**ATTACHMENT 5A**

**Emergency Plan Marked-up Pages – LaSalle Station**

Exelon Standardized Emergency Plan EP-AA-1000  
and  
Emergency Plan Annex EP-AA-1005

**Exelon Standardized Emergency Plan EP-AA-1000**

**Figure F-3: NRC Communications for Nuclear Response**

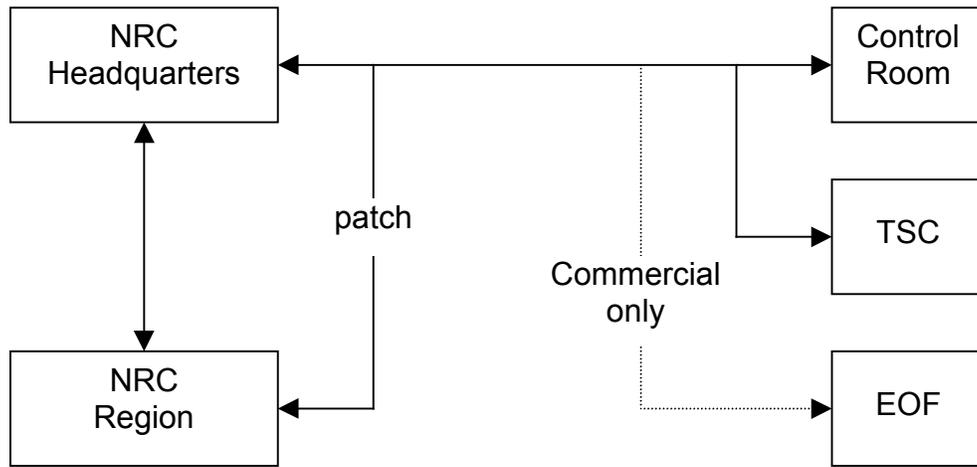
~~Health Physics Network (HPN): There also exists a separate dedicated telephone between the NRC, the TSC, and EOF for conveying health physics information to the NRC as requested or as an open line.~~

**NOTE:** ENS ~~and HPN~~ circuits may use the Federally maintained system, company tie lines or PBX as dedicated primary communications systems and have commercial backups.
